City of Phoenix

Staff Report: Z-66-D-96-1

Anthem West PCD

Proposal: Major amendment to the Anthem West PCD for C-2 with a height waiver to allow a four-story hotel

CONCEPTUAL LANDSCAPE RENDERING
PHOENIX, AZ

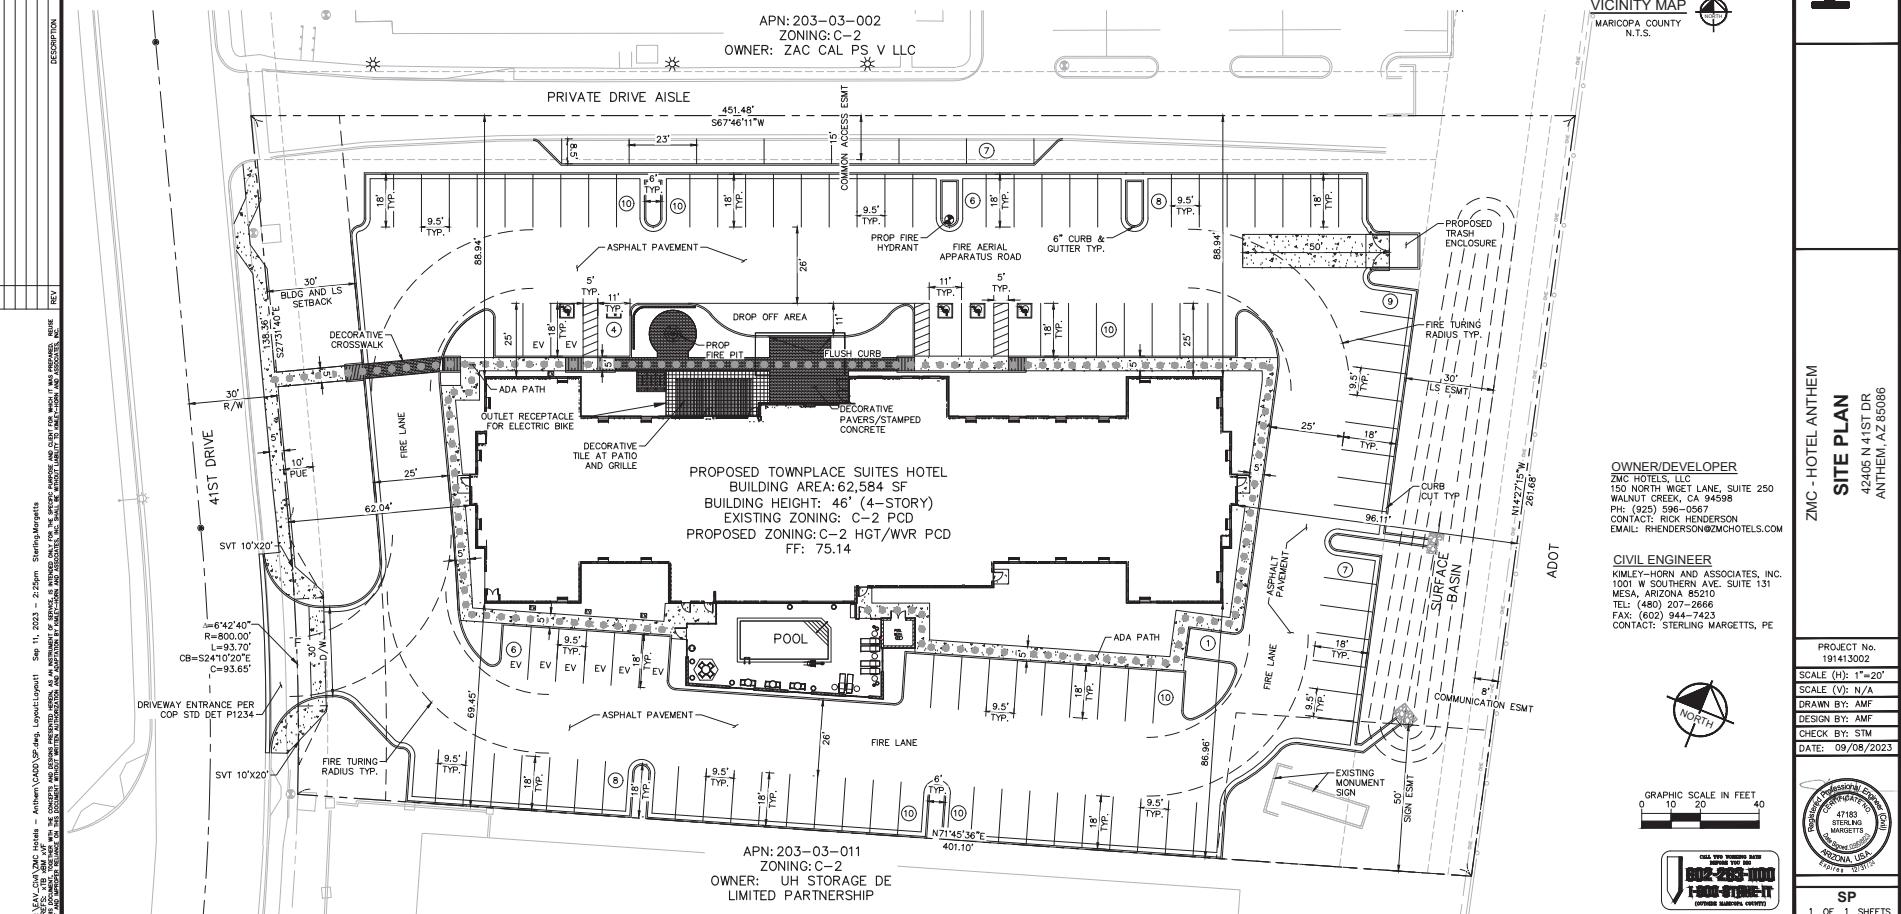
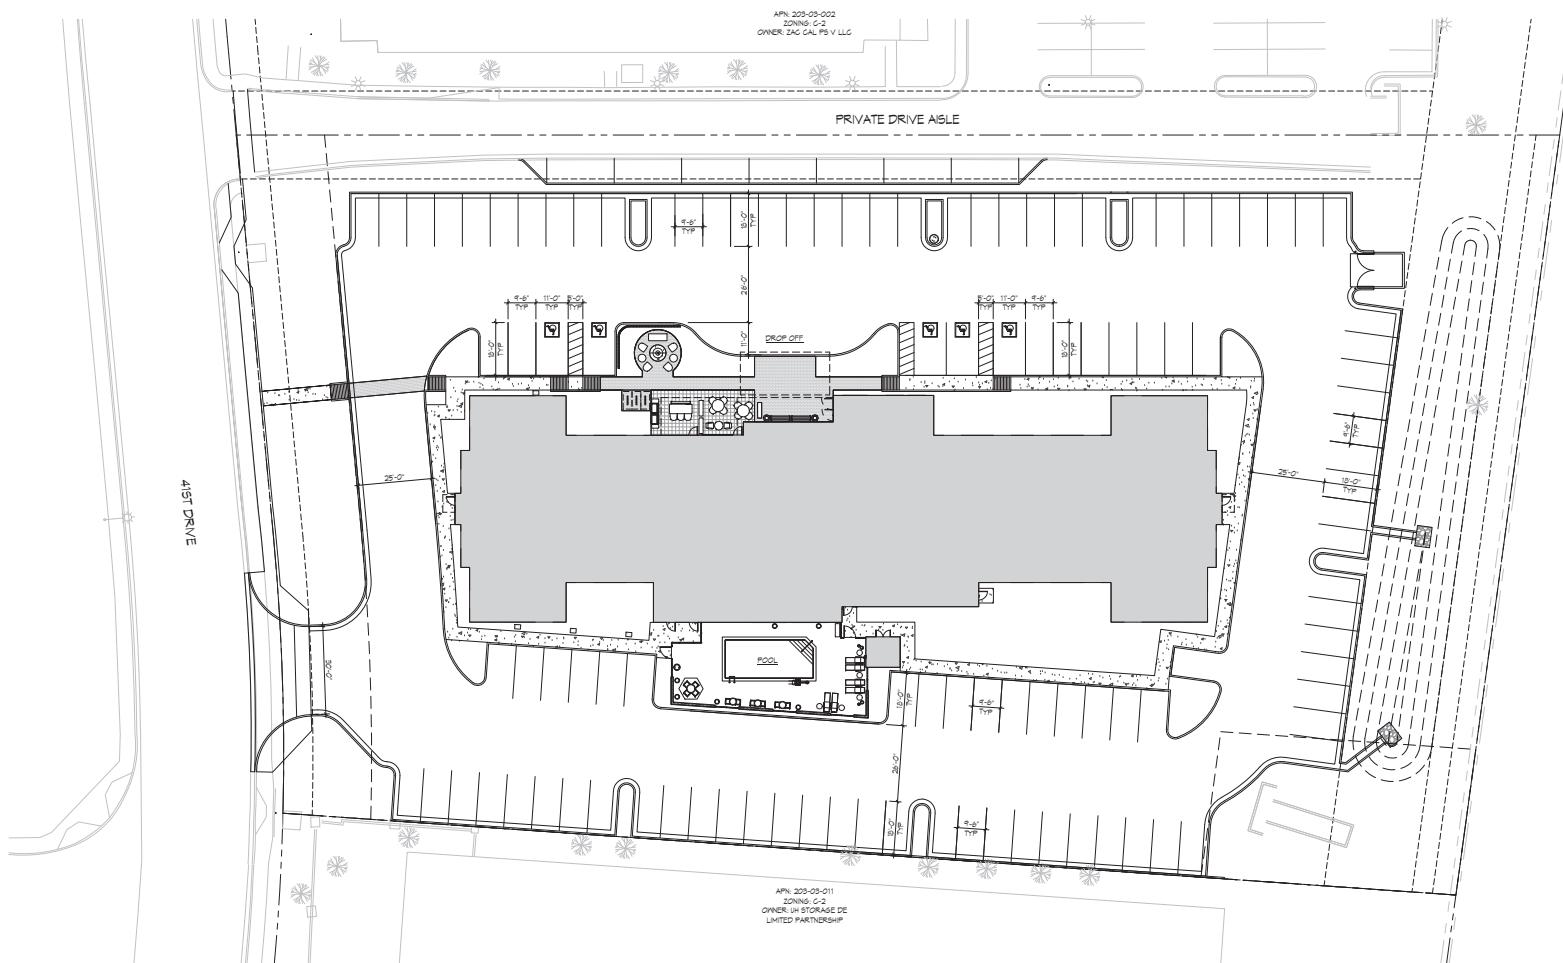
The landscape plan, attached as an exhibit, proposes drought-tolerant trees placed on both sides along the detached sidewalk adjacent to 41st Drive, drought-tolerant trees dispersed throughout the parking lot and around the building, and drought-tolerant trees along the western edge of the property, along with drought-tolerant shrubs, accents and vegetative groundcovers throughout the landscape areas.

In an effort to enhance the landscaping within the surface parking lot, staff recommends that the parking lot be landscaped a minimum of 12.5 percent with two-inch caliper, large canopy, drought-tolerant shade trees and drought-tolerant shrubs, accents and vegetative groundcovers to achieve a minimum of 75 percent live coverage at maturity. This is addressed in Stipulation No. 12.

12. A minimum of 12.5% of surface parking lot areas, exclusive of perimeter landscape setbacks, shall be landscaped. The surface parking lot areas shall be landscaped to the following standards and maintained with a watering system, as approved by the Planning and Development Department.

- a. Minimum 2-inch caliper large canopy drought-tolerant shade trees dispersed throughout the parking area to achieve a minimum 25% shade at maturity.

- b. Drought-tolerant shrubs, accents and vegetative groundcovers with a maximum mature height of two feet to achieve a minimum of 75% live coverage at maturity.

ARCHITECTURAL SITE PLAN

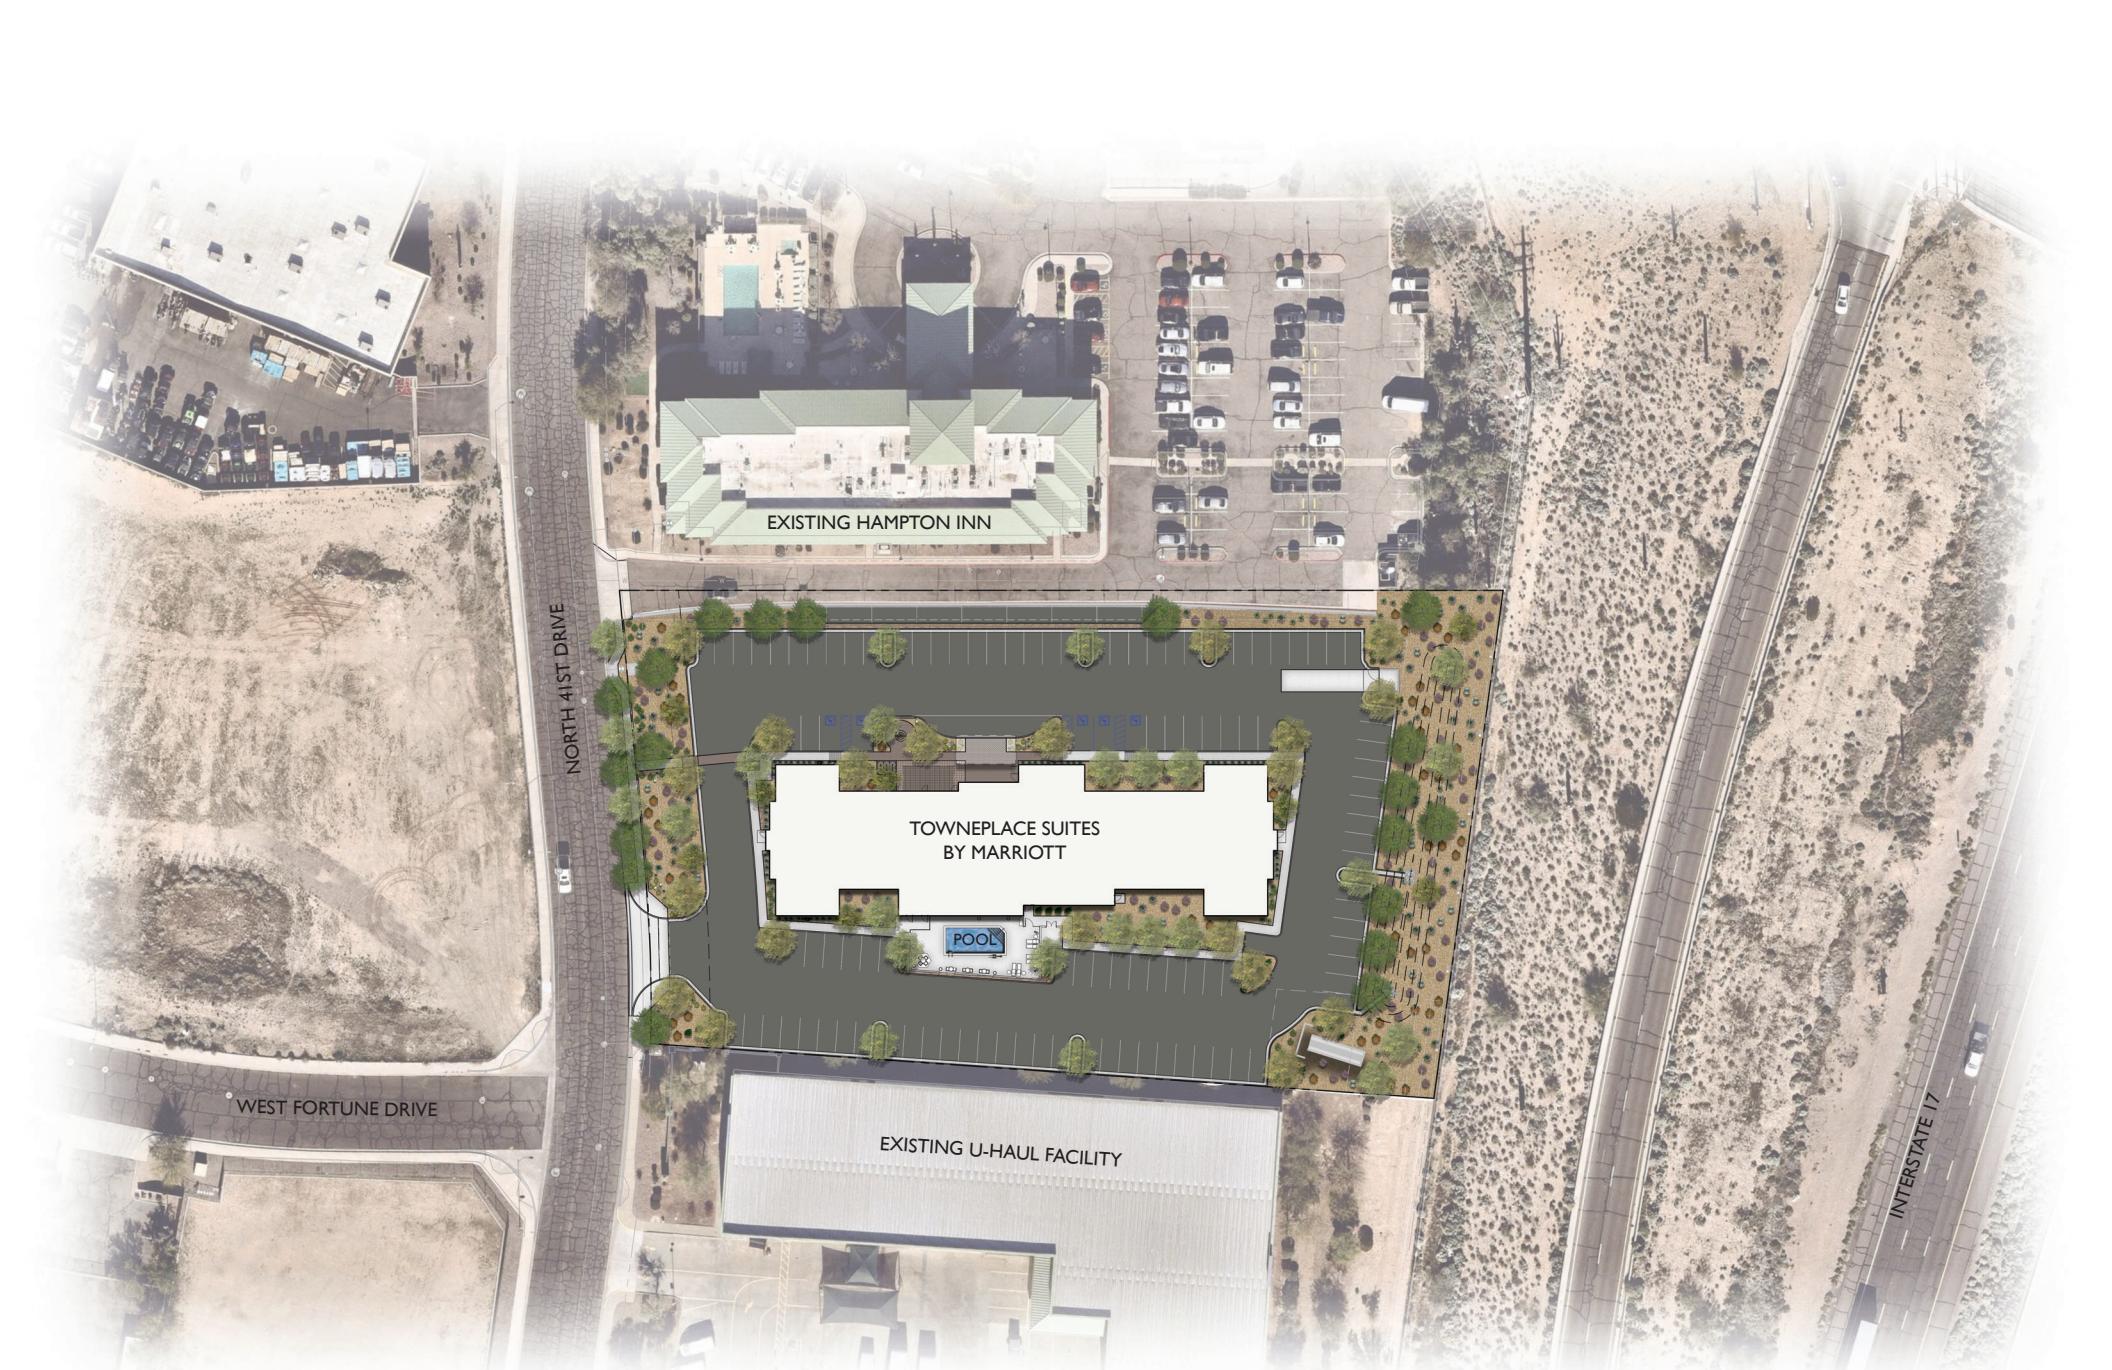
The proposed site plan meets minimum building and landscape setbacks, maximum lot coverage, and minimum parking requirements. Additionally, the proposed site plan is compatible with surrounding land uses. For these reasons, staff recommends general conformance with the site plan date stamped September 13, 2023. This is addressed in Stipulation No. 1.

In order to enhance pedestrian safety, staff recommends that where pedestrian walkways cross a vehicular path, the pathway shall be constructed of an alternative material or pavement treatment that visually contrasts the drive aisle surface. This is addressed in Stipulation No. 11.

1. The development shall be in general conformance with the site plan date stamped September 13, 2023, as modified by the following stipulations and as approved by the Planning and Development Department.

11. Where pedestrian walkways cross a vehicular path, the pathway shall be constructed of decorative pavers, stamped or colored concrete, or other pavement treatments that visually contrasts parking and drive aisle surfaces, as approved by the Planning and Development Department.
